Proposal #02: 5845-16-76, WISC 2026377
Stoughton - Madison
Exchange St to Larson Beach Rd
USH 51
Dane County

This is Addendum No. 01, which provides for the following:

ADDENDUM NO. 01

5845-16-76

Addendum No. 01
ID 5845-16-76
Revised Sheet 553
July 6, 2026

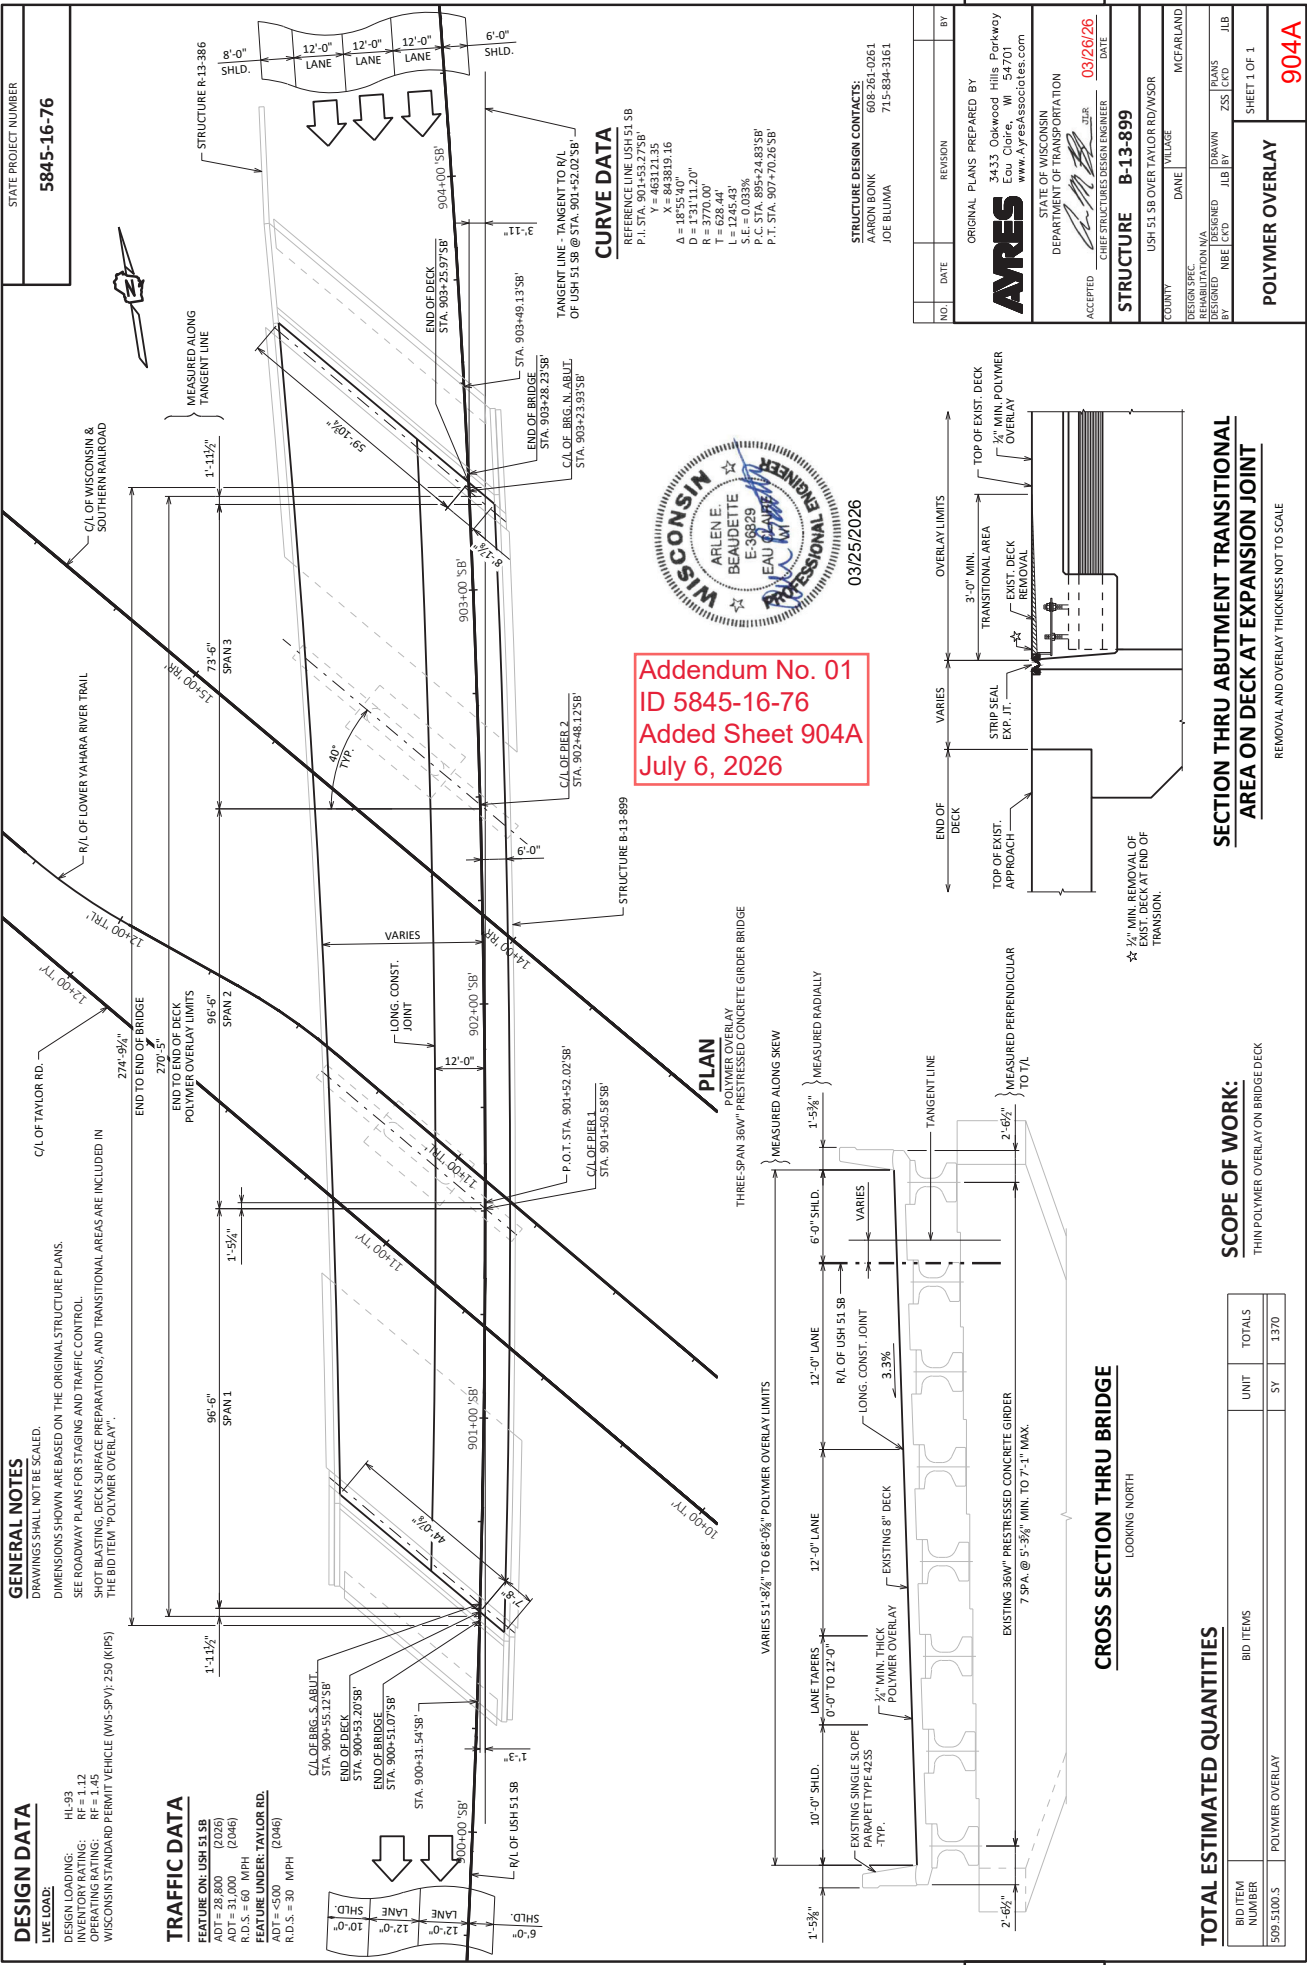
Revised Plan Sheets ID 5845-16-76	
Plan Sheet	Plan Sheet Title (brief description of changes to sheet)
62	Removal Details (Added Removing Concrete Base and Removing, Salvage and Reinstall Security Camera Pole note)
210	Underpass Lighting and USGS Conduit & Cabinet (Added Concrete Base Type 5 and Removing, Salvage and Reinstall Security Camera Pole note and location)
553	Miscellaneous Quantities (Added Removing Concrete Base, Concrete Base Type 5 and Removing, Salvage and Reinstall Security Camera Pole MQ Table)

BABCOCK PARK SECURITY CAMERA POLE

*
654.0105
SPECIAL (053 REMOVE,
SALVAGE AND REINSTALL
TYPE 5
SECURITY CAMERA POLE
EACH

CATEGORY	STATION	LOCATION	EACH	REMARKS
STAGE 2				
0010	50+73 'UPO'	4.5' RT	1	BABCOCK PARK SECURITY CAMERA POLE
0010	50+45 'UPO'	12' RT	1	BABCOCK PARK SECURITY CAMERA POLE
TOTALS 0010			1	1

Addendum No. 01
ID 5845-16-76
Added Sheet 904A
July 6, 2026

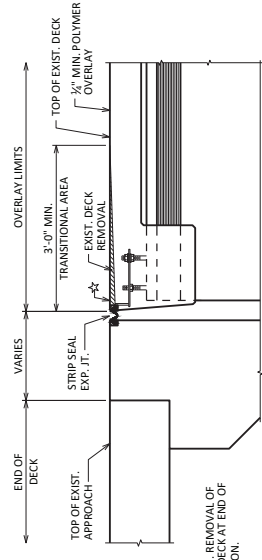
Added Plan Sheets ID 5845-06-76	
Plan Sheet	Plan Sheet Title (brief description of why sheet was added)
904A	Polymer Overlay Structure B-13-899 (Sheet was missing from the original plan set, includes structure quantities for its polymer overlay)

THIN POLYMER OVERLAY ON BRIDGE DECK
